*Response to Nevada Division of Environmental Protection Comments  
dated March 29, 2021, Shallow Groundwater Conceptual Site Model Report, Western Hook  
Development Area, BMI Eastside Common Area Henderson, Nevada, dated December 4, 2020*

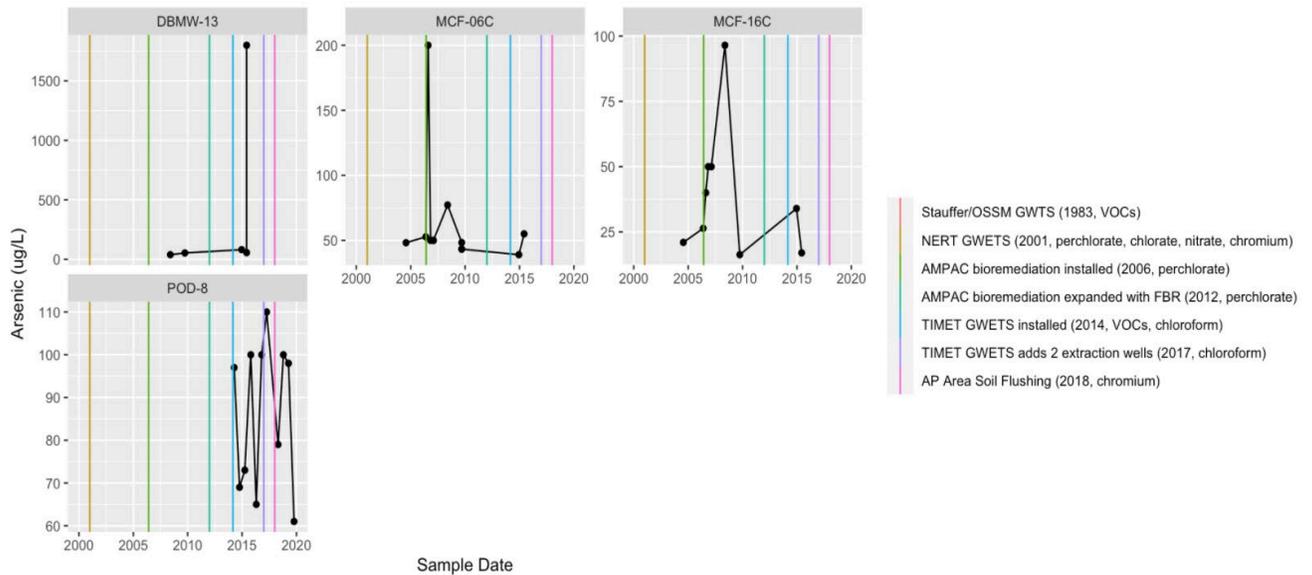
Major remediation activities conducted at the BMI complex, such as installations of interceptor well fields and trenches (as described in Section 3.7) should be related to the conceptual site model of the Western Hook. The second paragraph of Section 1 states that “the impact [on the Western Hook] of various groundwater remediation programs in the Site vicinity” is a purpose of the document.

Section 5.5 states that remediation programs do have some effect on contaminant concentrations at the Western Hook. In particular, the OSSM GWTS is said to have kept beta-BHC concentrations in the Western Hook low, and the NERT GWETS has had the collateral effect of reducing arsenic concentrations. Additionally, the last sentence of Section 5.5 states, “With the exception of the very southeastern portion of the Western Hook, the groundwater treatment systems in place appear to be having a positive incidental effect on arsenic plume control and concentration reduction.” Further explain the basis for this statement, despite the fact that only 4 wells in the Western Hook area had arsenic concentrations that decreased in time. Specifically reference figures in the explanation.

Where possible, relate the trends observed in concentration data over time to the timing of the remediation program implementation and the affected contaminants. For example, indicate the remediation activities on the time series of Appendix B in a manner similar to the plot shown below.

**Response:** The comment correctly recounts that the CSM states that data from the Western Hook indicates that remediation programs do have some effect on contaminant concentrations at the Western Hook. However, the comment apparently misinterprets the phrase, “... *the groundwater treatment systems in place appear to be having a positive incidental effect on arsenic plume control and concentration reduction.*”, to mean that the groundwater treatment systems in place appear to be having a positive comprehensive effect. That is not stated nor implied. It is correct to say that there are incidences of concentration declination with time, and therefore the apparent positive effect is incidental. This statement recognizes that the concentration trends in all of the Western Hook vicinity monitoring wells are not consistent. No further analysis is needed to provide the basis for the statement.

Lastly, it is beyond the scope of BRC’s interest and CSM to understand and analyze the details of the upgradient plume control efforts. It is sufficient to know that: 1) there have been high concentrations of constituents located at upgradient locations which have acted as sources of contamination to groundwater that is flowing onto the Western Hook property, and 2) various responsible upgradient entities are actively remediating groundwater under the regulatory oversight of NDEP. It is assumed that, with time, contaminated groundwater originating from upgradient locations will be fully remediated to the appropriate regulatory standards.
